REAR JCT BOX COVER UPGRADE

On the vehicles affected by this bulletin, to prevent premature corrosion of the rear junction box components, replace the junction box cover with a late model "central mount" cover.

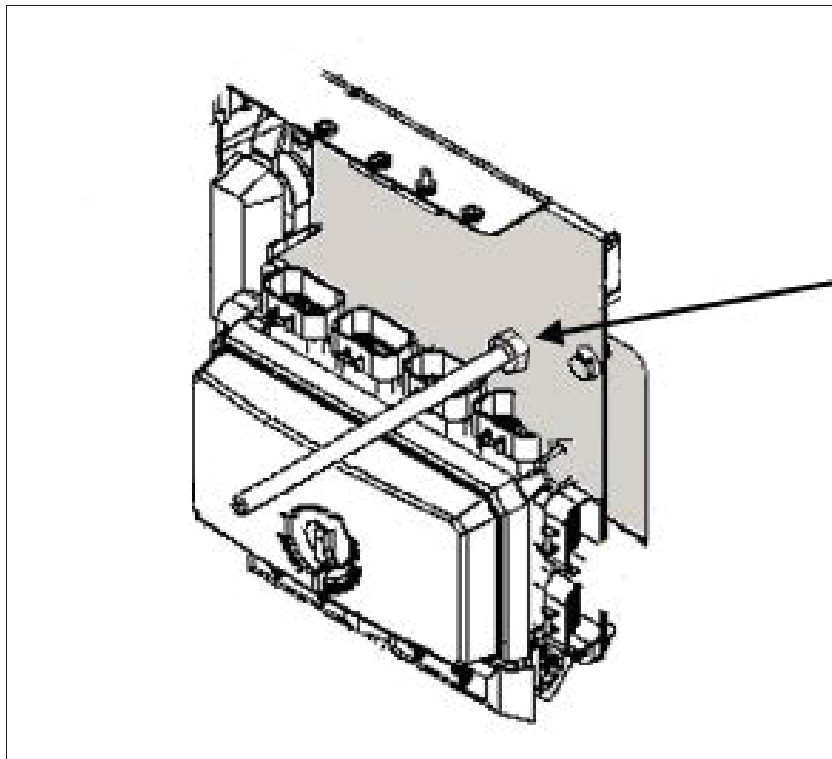
- 1) Open the right side engine compartment to access the rear junction box and remove the junction box cover.

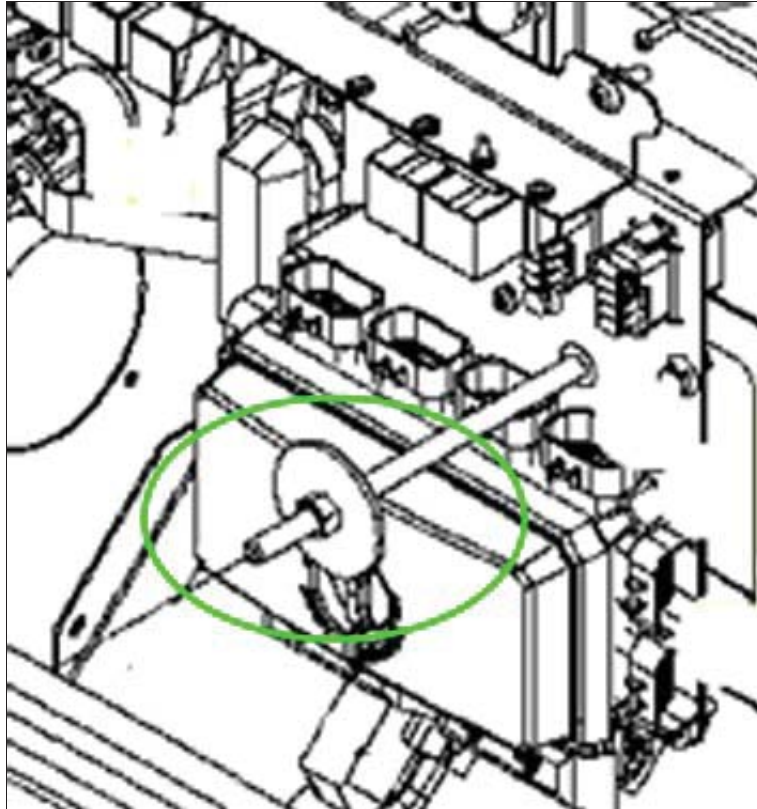
- 2) On the fuse box back plate, drill a 3/8" (10mm) hole following the template and image below (move away wires and harness as required).

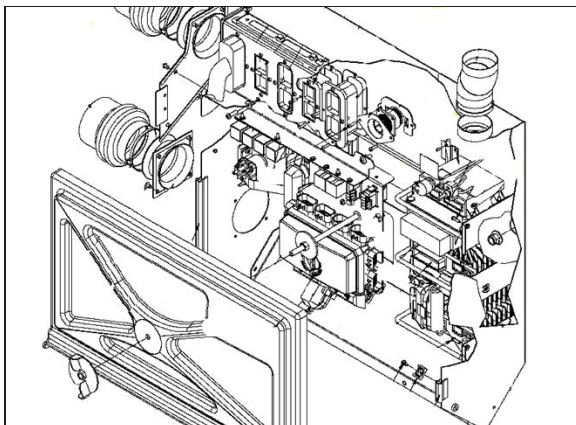
- 3) Insert a 3/8" stainless steel threaded rod of the correct length in the previously drilled hole (rod must stick out of the new central mount cover about 1/2" min), secure the rod to the back plate using two #500102 3/8 SS nuts, one on each side of the plate.
